North Anna 3
Combined
License
Application

Part 10: Tier 1/
ITAAC/Proposed
License
Conditions

Revision 8

June 2016

North Anna Unit 3 Specific Figure 2.13.1-1 Sh 1. Unit 3 Electric Power Distribution System Functional Arrangement

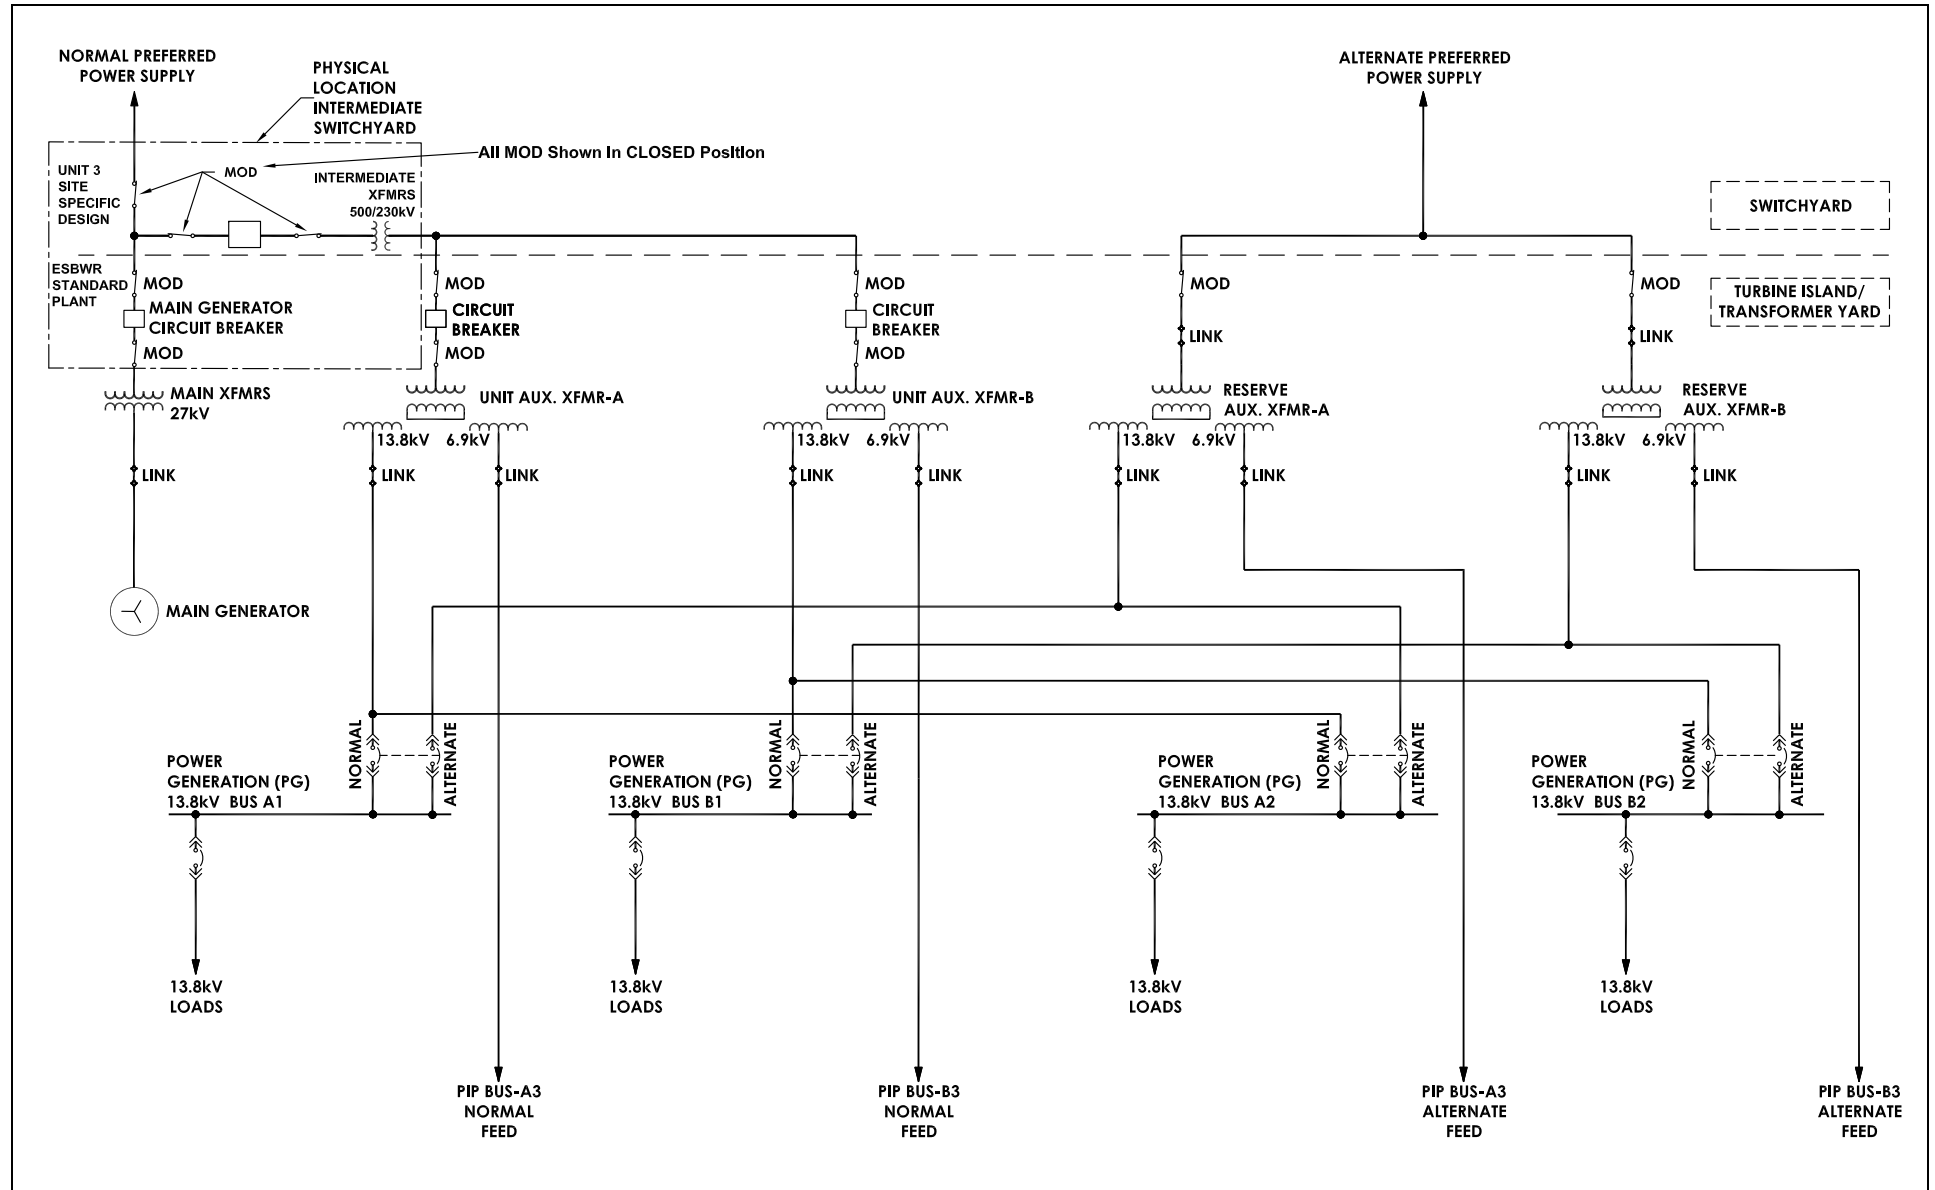
There is a departure from [DCD Tier 1, Section 2.13.1, Figure 2.13.1-1, Sheet 1](#), as described in [COLA Part 7](#). The Unit 3 Electric Power Distribution System Functional Arrangement is as shown on the next page, which provides the North Anna Unit 3 Specific Figure 2.13.1-1, Sheet 1. This Unit 3 specific figure replaces [DCD Tier 1 Figure 2.13.1-1, Sheet 1](#), where the figure is cited in [DCD Tier 1, Section 2.13.1](#).
